In the Matter of
CONSUMERS POWER COMPANY
(Midland Plant, Units 1 and 2)
Docket Nos. 50-329 and 50-330
(Operating Licenses Proceeding)

SUBJECT: MIDLAND LAND 2 EXCESSIVE SETTLEMENT OF
DIESEL GENERATOR BUILDING FOUNDATIONS (A/I F30437H1)

MIDLAND NUCLEAR PLANT -
IT NO 1, DOCKET NO 50-329
UNIT NO 2, DOCKET NO 50-330
SETTLEMENT OF DIESEL GENERATOR FOUNDATIONS AND BUILDING

INTERIM REPORT # 1

DIESEL GENERATOR BLDG.
 SETTLEMENT DATA AS OF 9-19-78
 (INCHES)

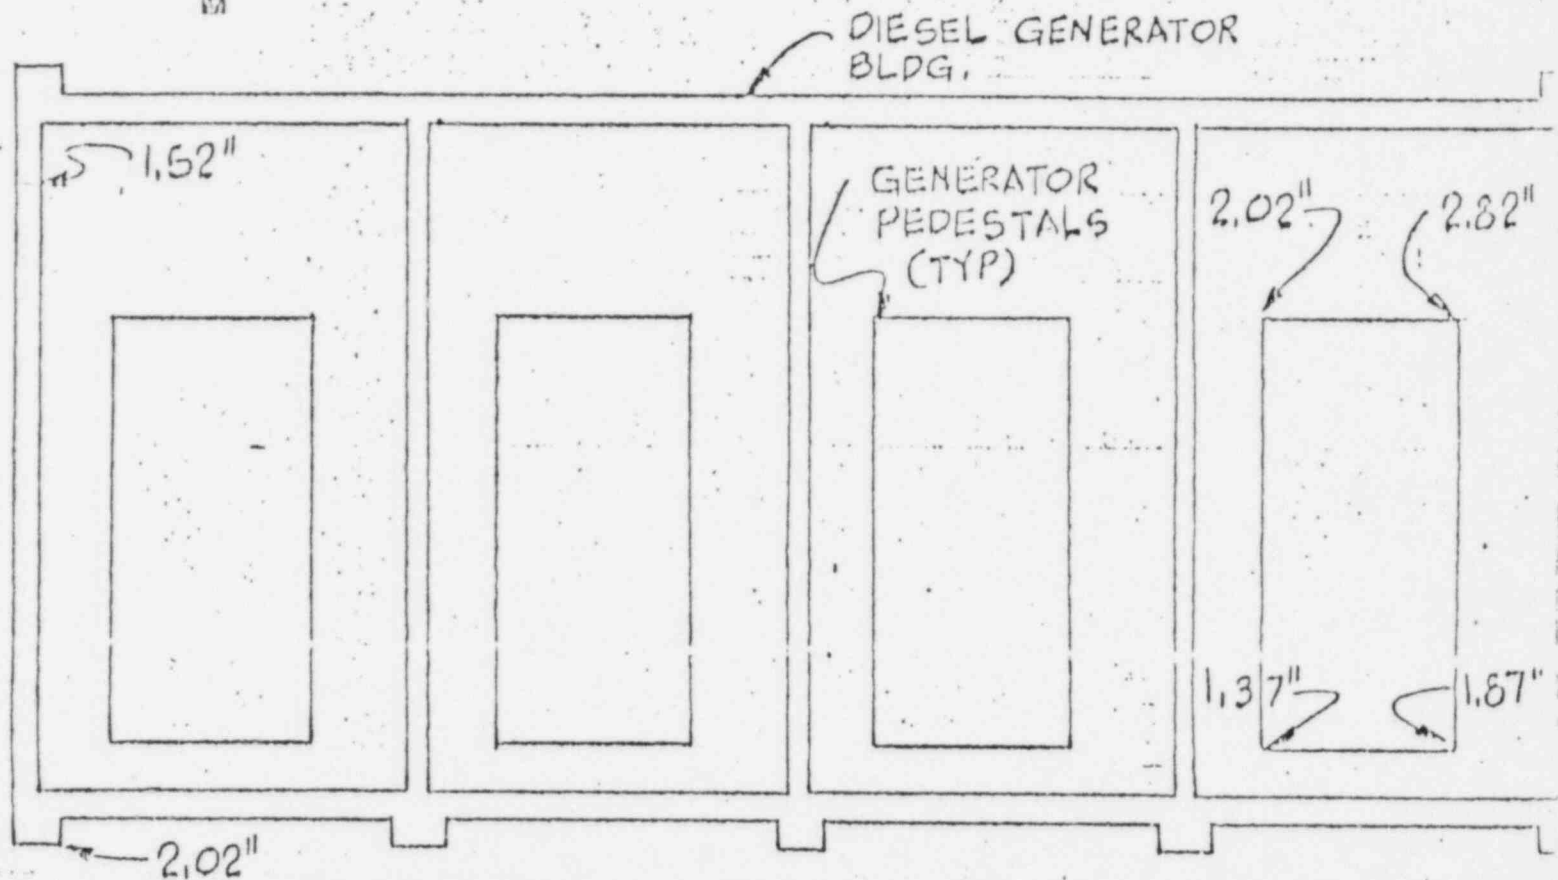
The general foundation and building settlements, as of September 19, 1978, are shown on Figure 1 (attached).

Due to the magnitude of the settlements observed, a soils boring program was started. Based on the borings completed to date, the fill under the building has variable strength properties ranging from good to poor.
